**ADDENDUM # 10**

**WEGO Transit and Fleet Operations Center Expansion**

**Request for Proposal No: RFP-22-2024-AD**  
**Issue Date of Addendum: January 16, 2025**  
**Proposal Submission Deadline: January 23, 2025 at 2:00 p.m. ET**

**ADDENDUM No.2**

Title <b>2ND FLOOR POWER AND SYSTEMS PLAN</b>			
Drawn By: KM	Designed By: JR	Approved By: KS	Date: NOV 2024
Project No. 24-186		Scale AS NOTED	
Drawing No. <b>E301</b>		Sheet	Revision <b>3</b>

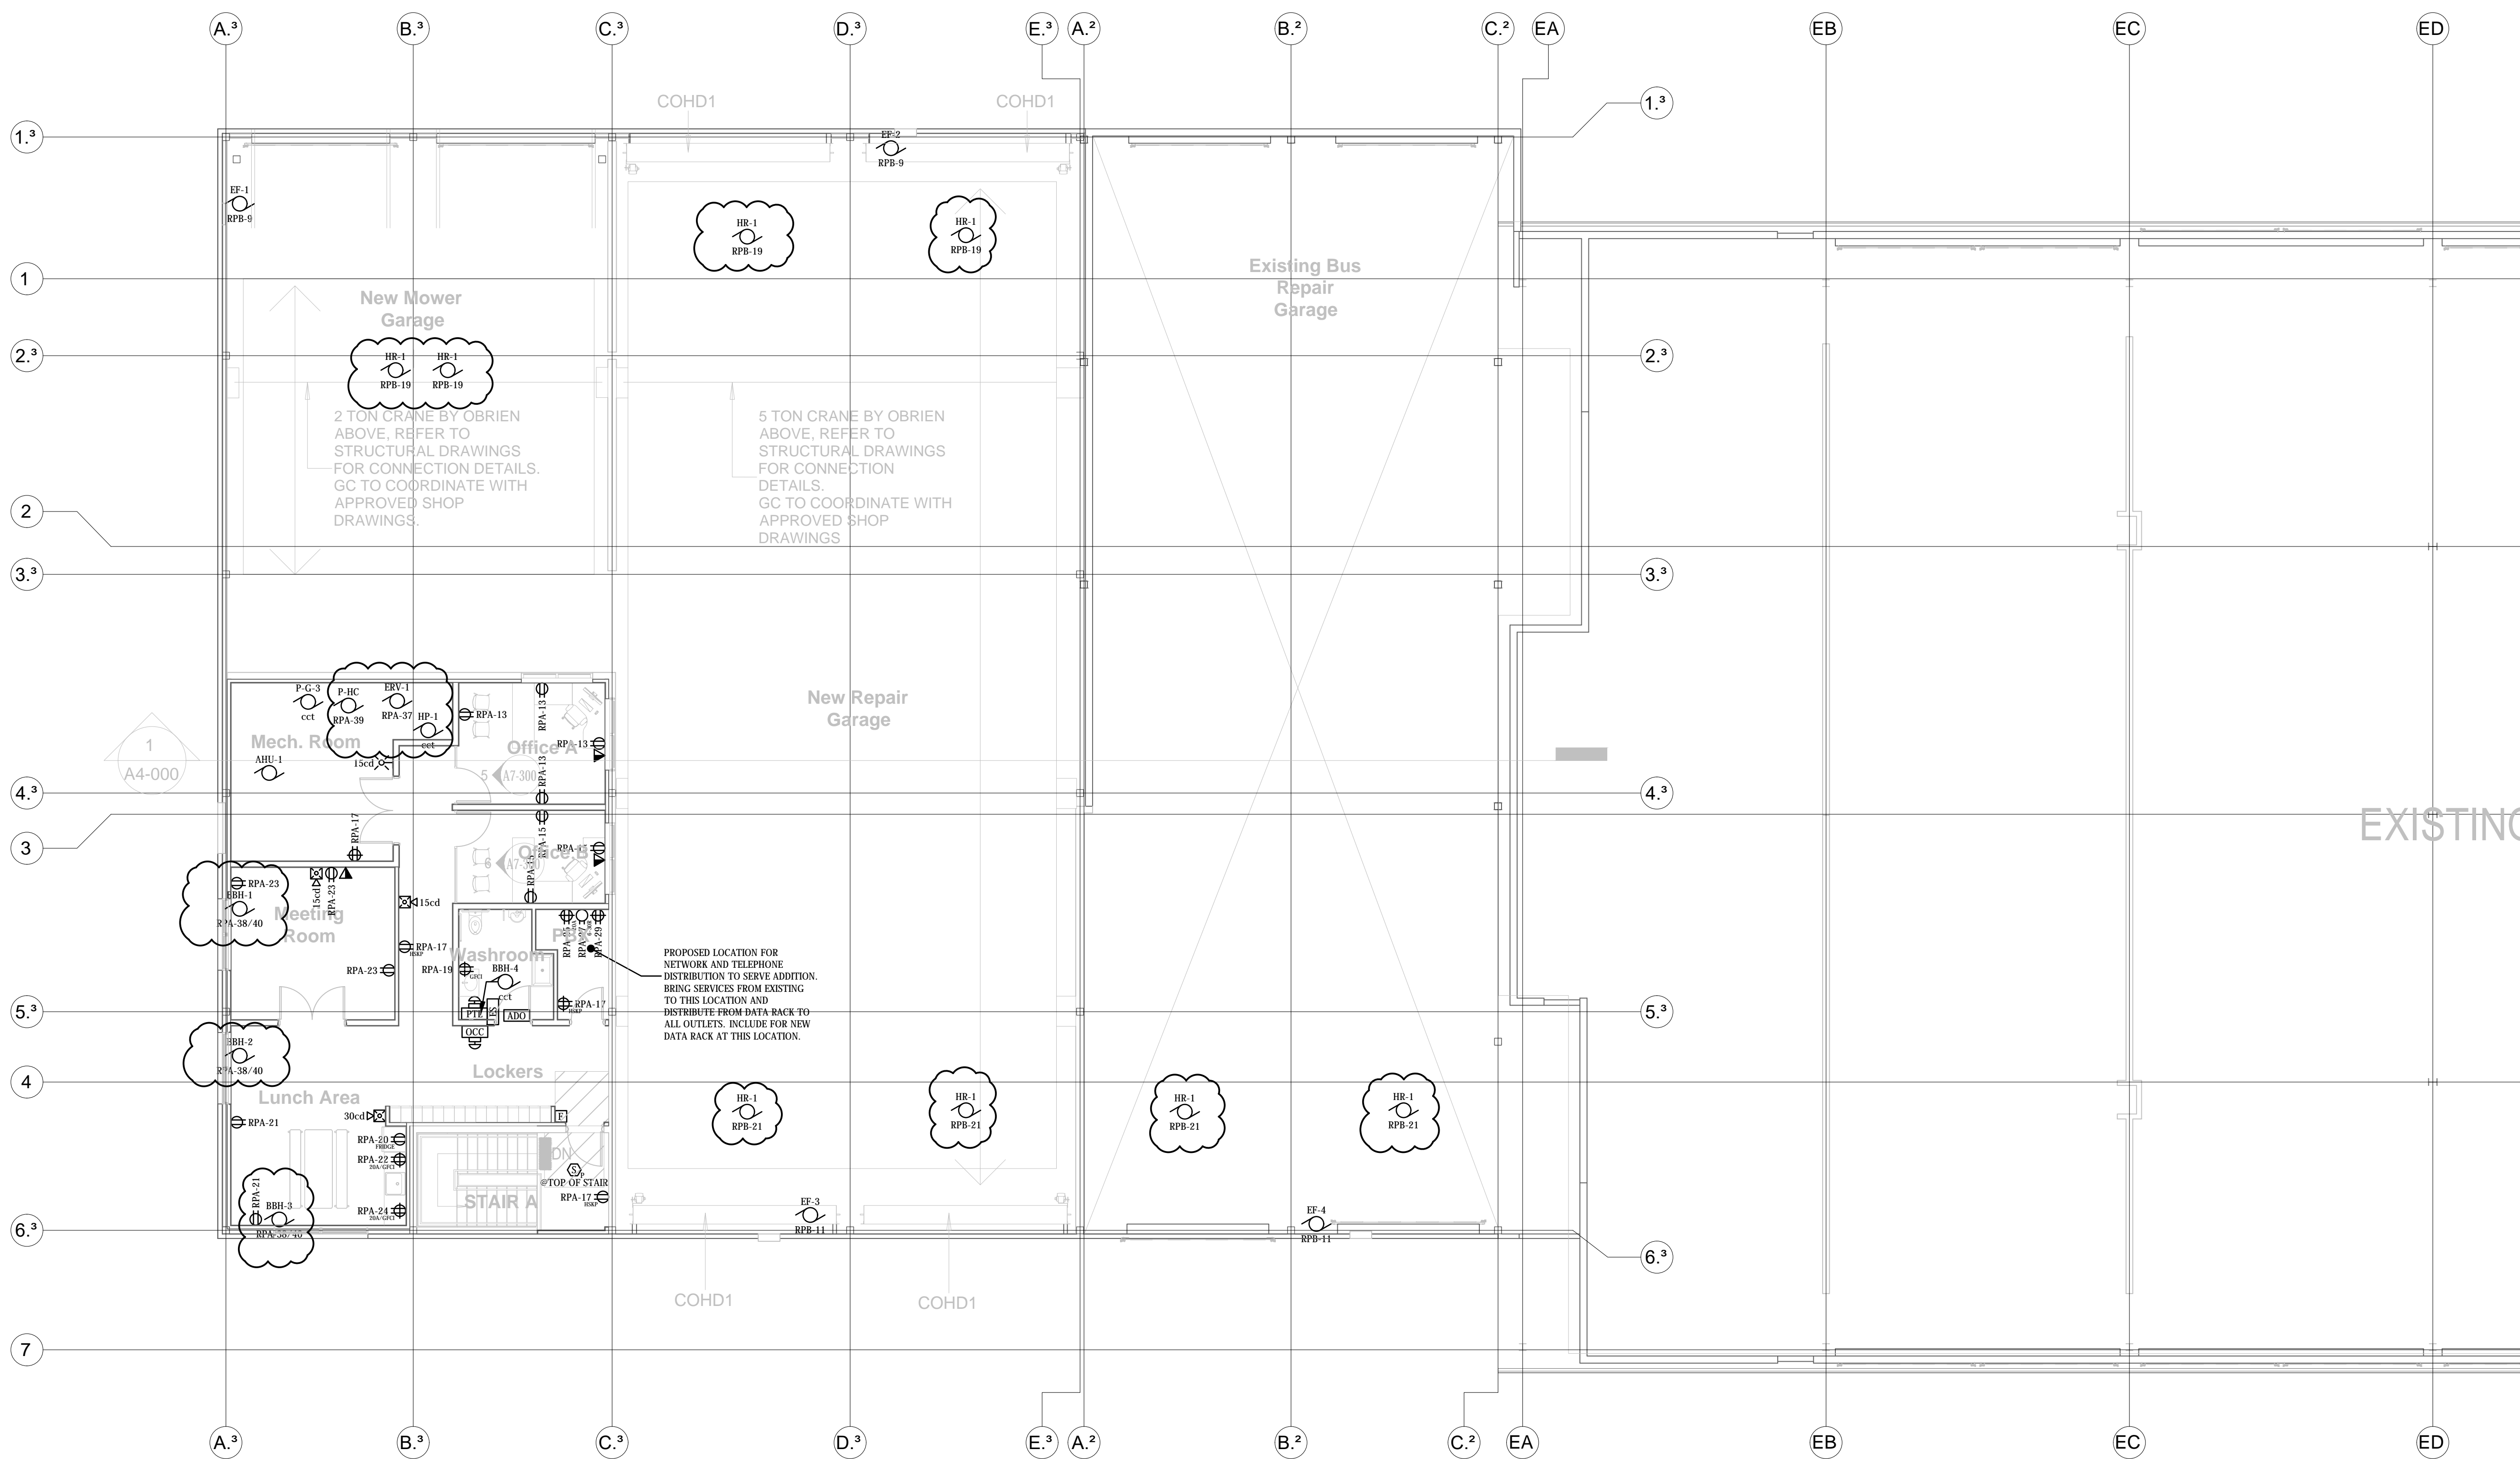
**1. Reference Drawing E301**

1.1. Refer to updated drawing for added power connections to vehicle exhaust extraction hose reels.

Title <b>ELECTRICAL DETAILS</b>			
Drawn By: <b>KM</b>	Designed By: <b>JR</b>	Approved By: <b>KS</b>	Date: <b>NOV 2024</b>
Project No. <b>24-186</b>		Scale <b>NTS</b>	
Drawing No. <b>E700</b>	Sheet	Revision <b>3</b>

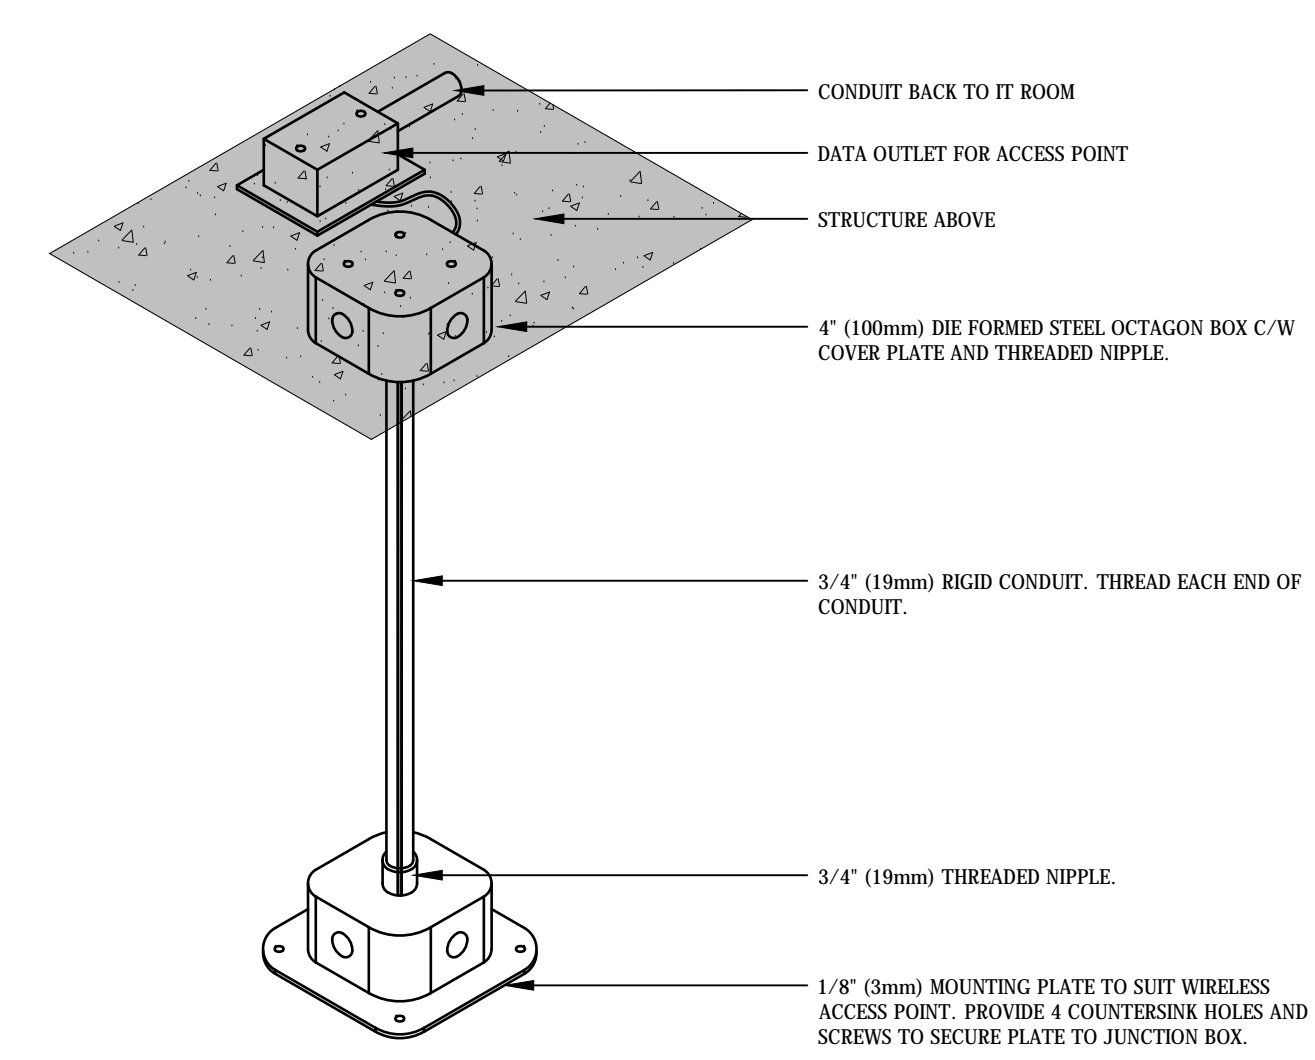
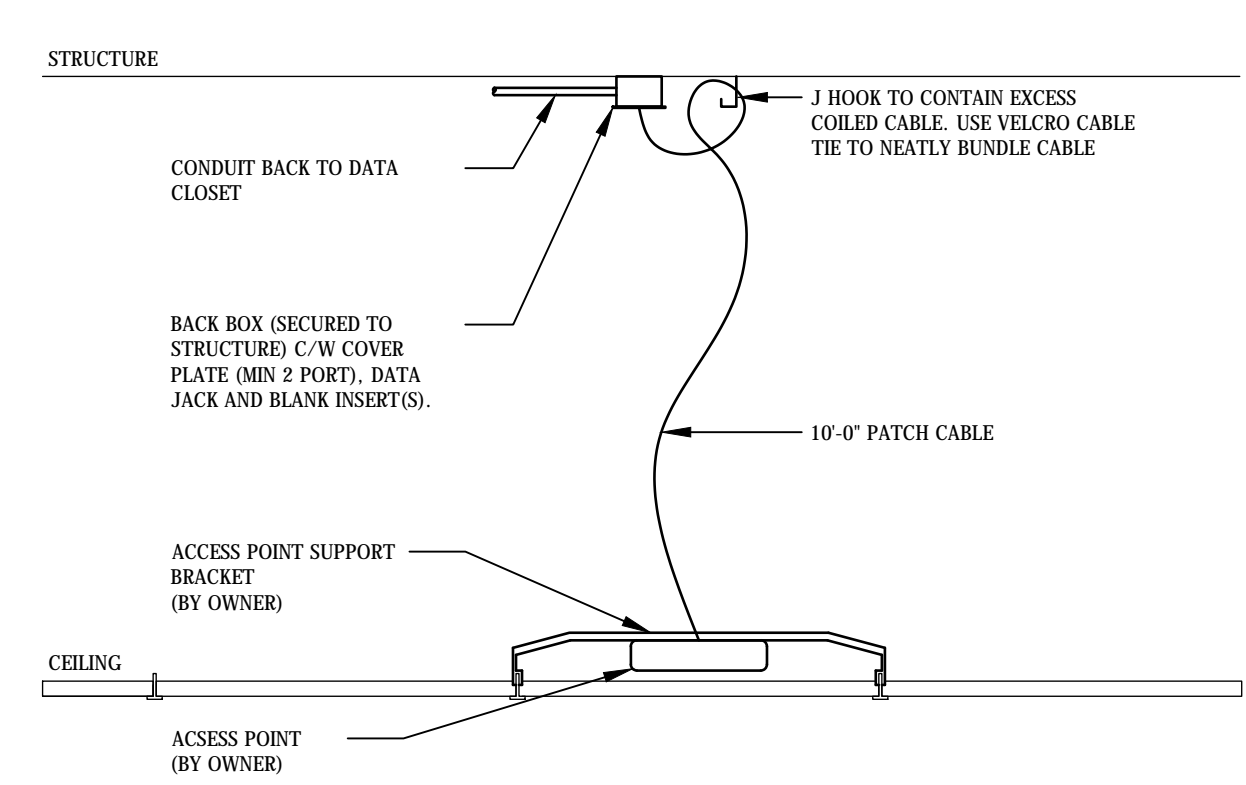
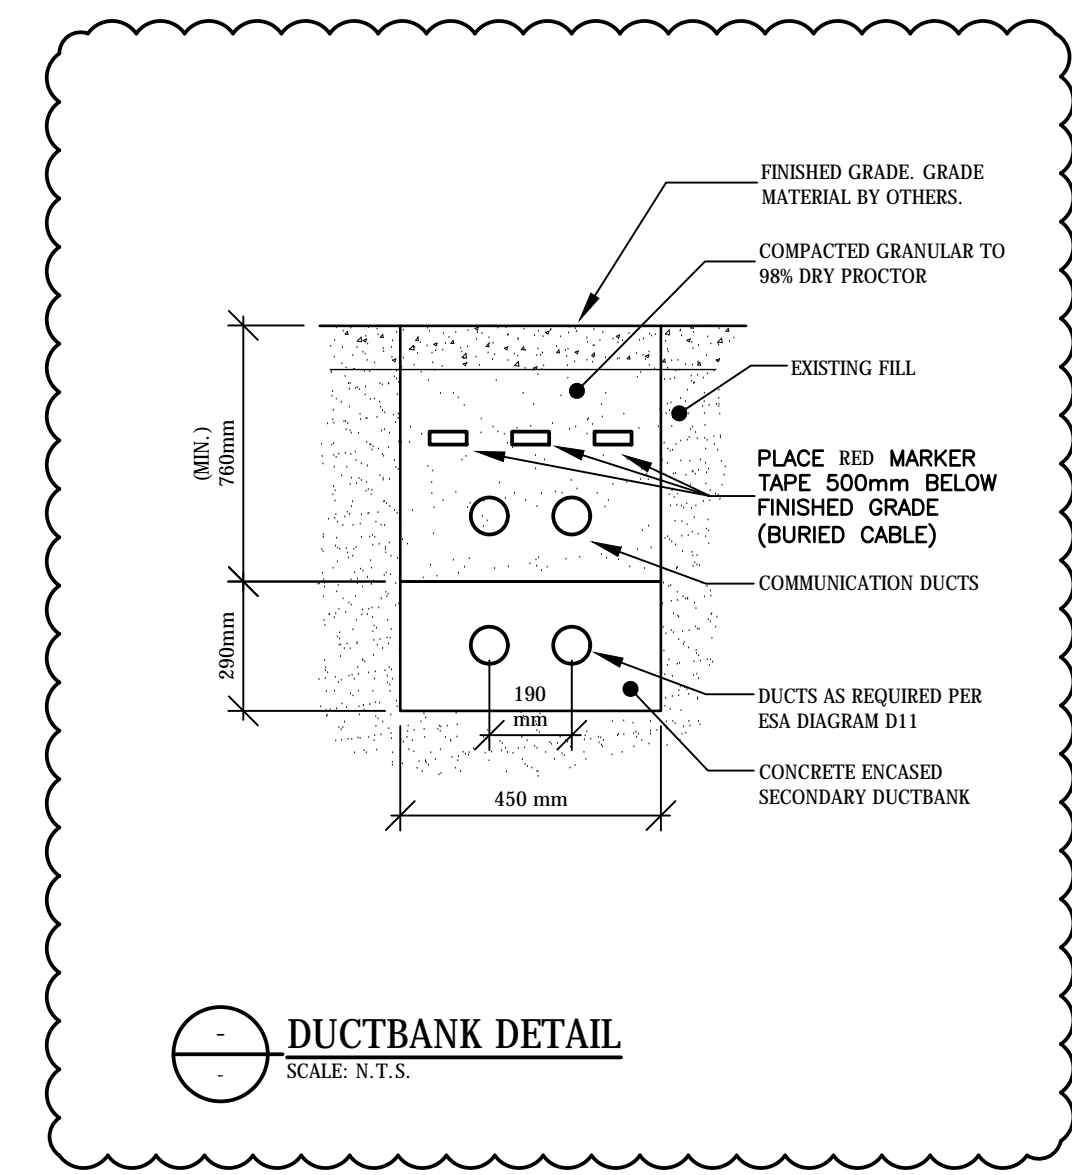
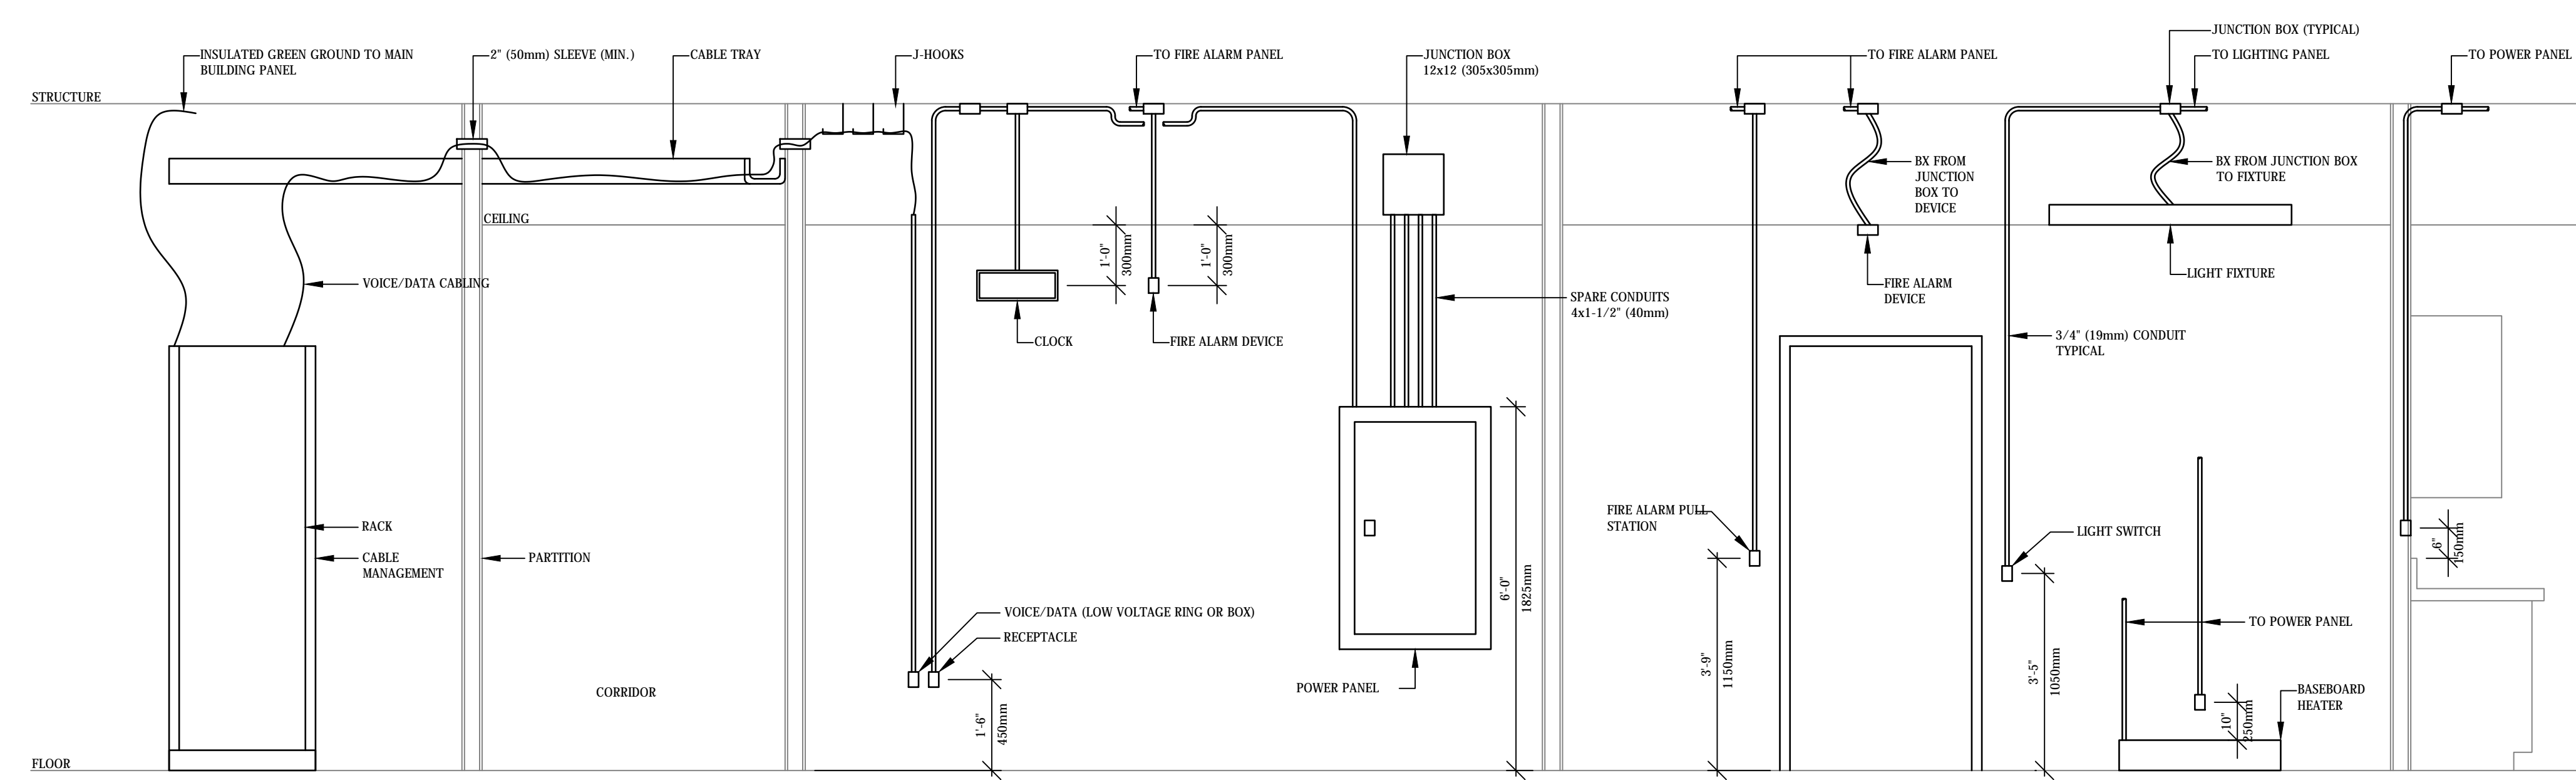
**3. Reference Drawing E700**

3.1. Refer to updated drawing for added duct bank detail.
